CCA ELECTRONICS, INC.

SCHEMATIC, FM5000G, 1 PHASE

SIZE D | BY JWH | DATE 12/26/90 | DWG NO. DSC06534 | REV C

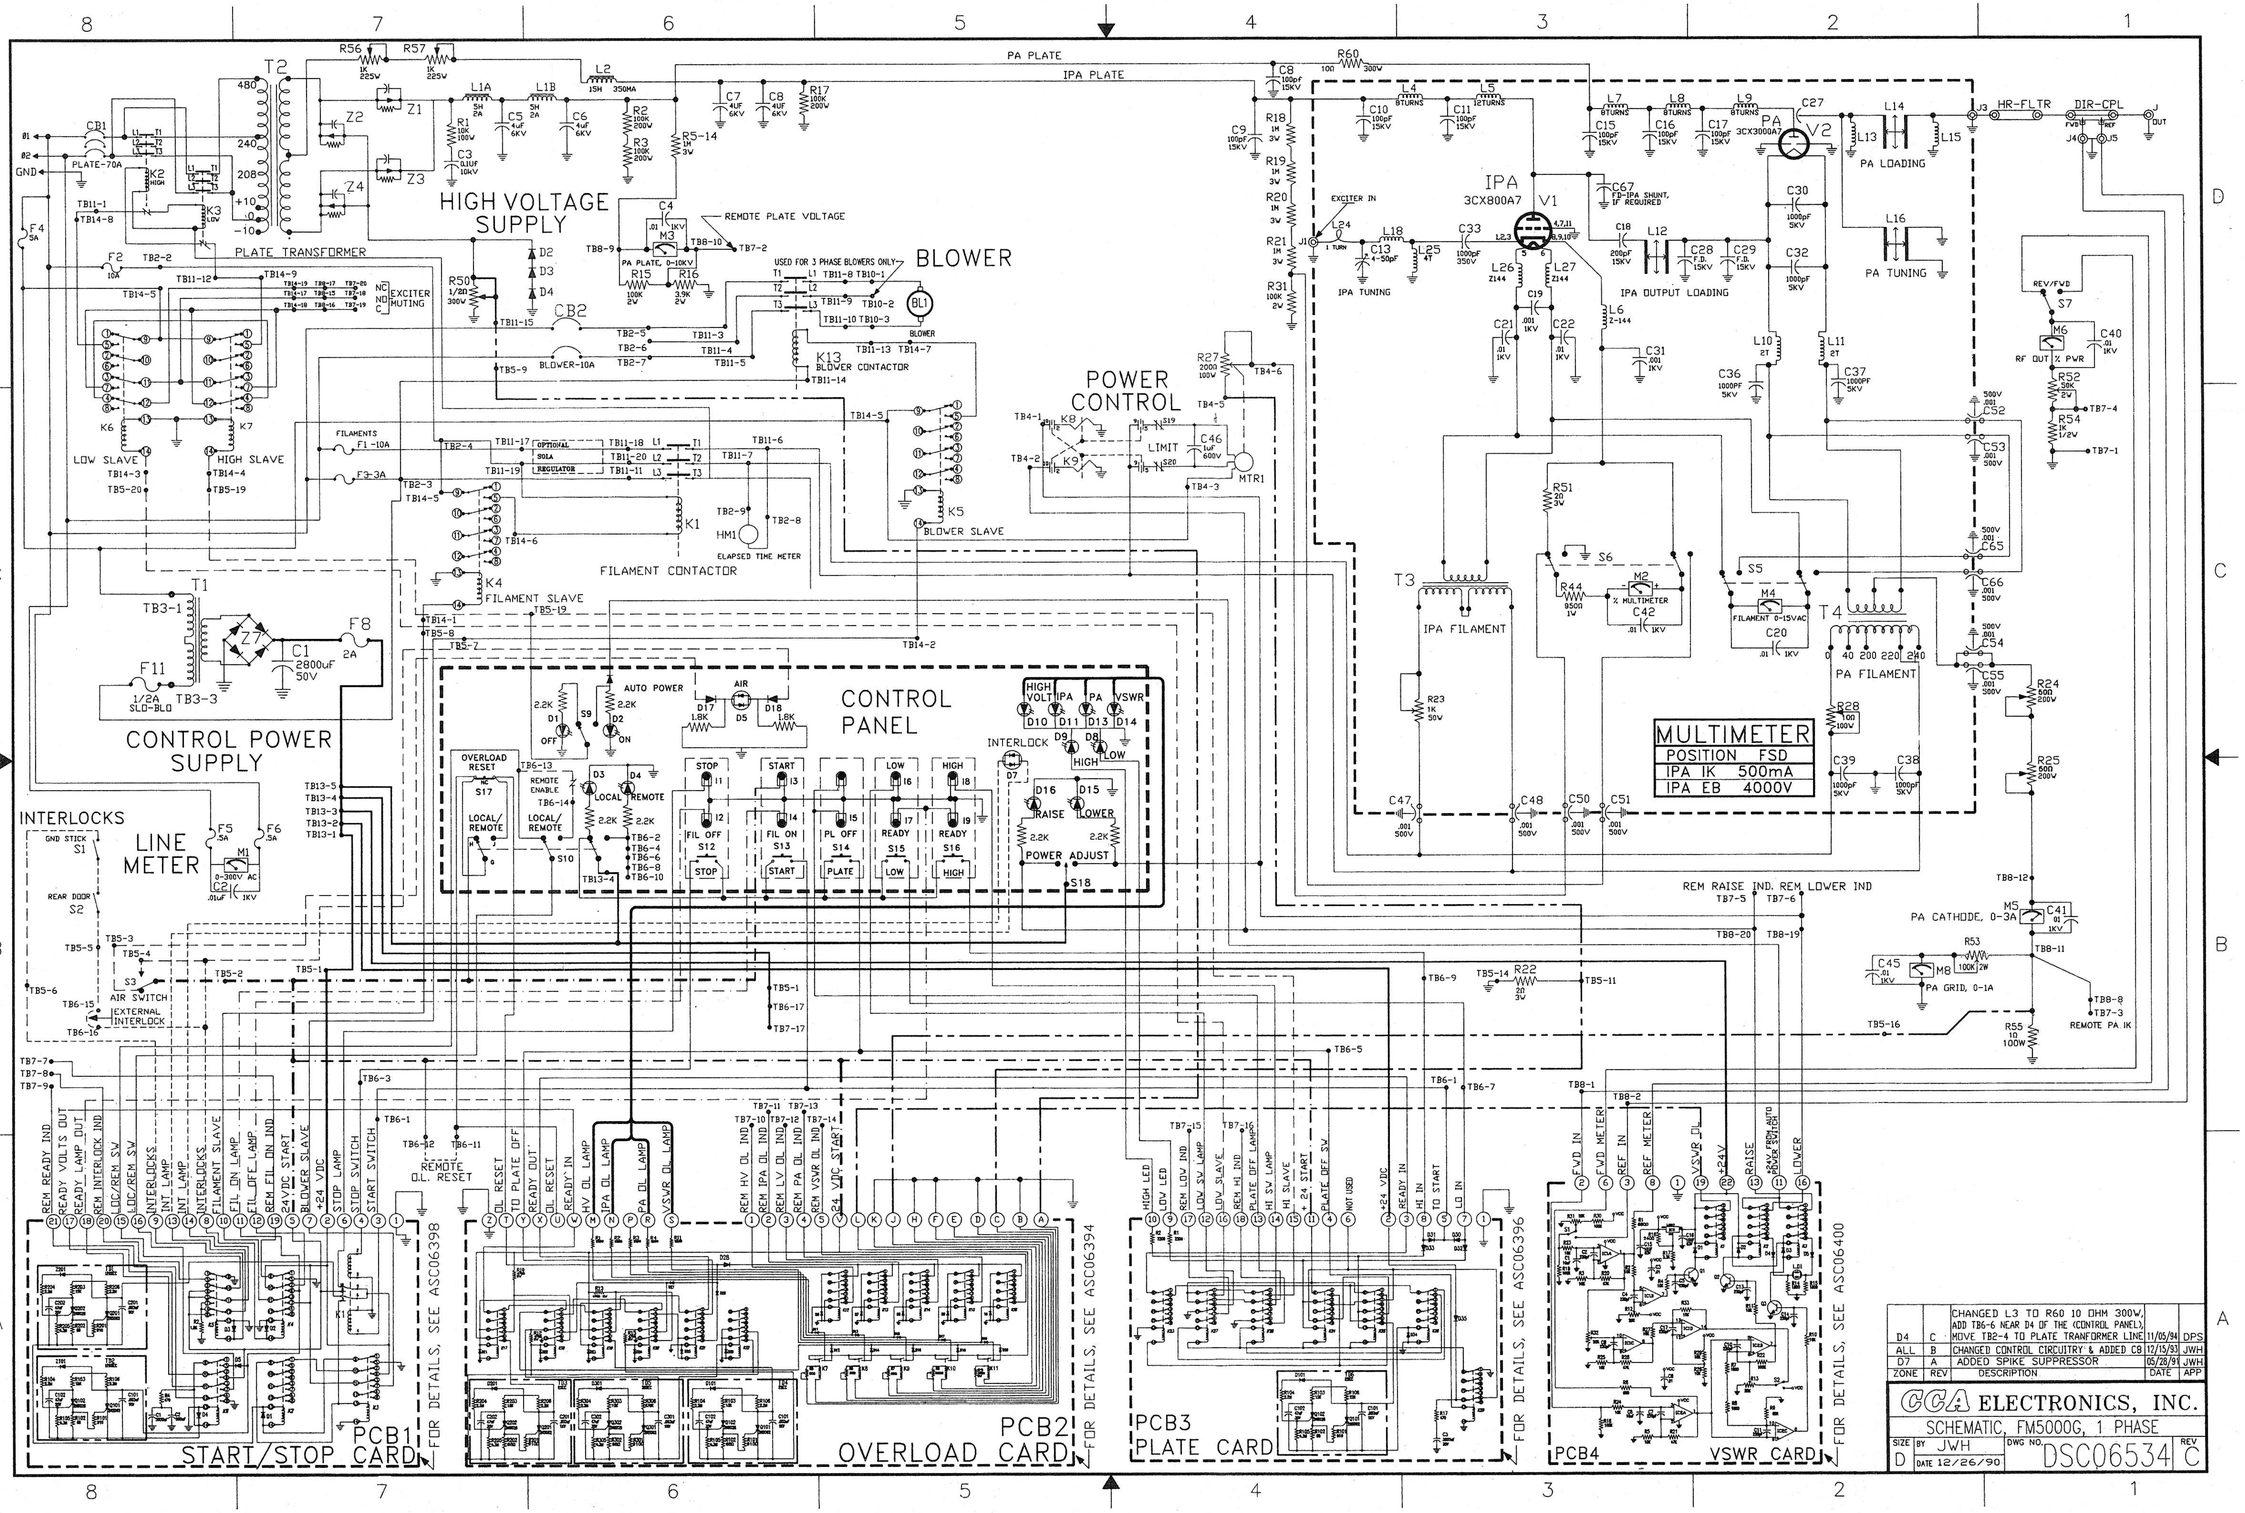
ZONE	REV	DESCRIPTION	DATE	APP
D4	C	CHANGED L3 TO R60 10 OHM 300W, ADD TB6-6 NEAR D4 OF THE (CONTROL PANEL), MOVE TB2-4 TO PLATE TRANFORMER LINE	11/05/94	DPS
ALL	B	CHANGED CONTROL CIRCUITRY & ADDED CB	12/15/93	JWH
D7	A	ADDED SPIKE SUPPRESSOR	05/28/91	JWH
